PCN Number:	20180615000.2**A**	**PCN Date:**	Oct 15, 2018
Title:	TLV70025Q1, TLV70033Q Design Change and Datasheet Updates		
Customer Contact:	PCN Manager	**Dept:**	Quality Services
Proposed 1st Ship Date:	Dec 21, 2018	**Estimated Sample Availability:**	Date provided at sample request.

This notification is to inform of a design change to the TLV70025QDDCRQ1 and TLV70033QDDCRQ1 devices. Affected devices are listed in the Product Affected section of this document. The design changes are summarized as follows:

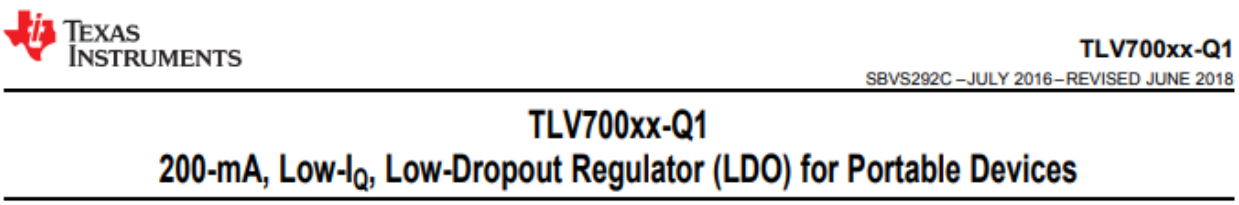
Revision A is to communicate changes in the minimum and maximum current limit sense resistor values that were in error or not communicated on the original PCN notification. The new datasheet revision is highlighted and **bolded** below.
There is no change proposed 1st ship date of December 21, 2018.

1. Metal 3 change to eliminate cold temp bandgap startup failures.
2. The feedback resistor divider was re-wired to use the existing OTP (One Time Programming EPROM cell) control instead of metal mask programming.
3. ~~The current limit sense resistor value was changed to move the minimum current limit from 220mA to 330mA to provide more margin in manufacturing.~~ **The minimum current limit will remain at 220mA.**
4. A spare bond pad and its associated ESD cell were removed.
5. **The current limit sense resistor value was changed to move the maximum current limit from 550 to 860mA.**
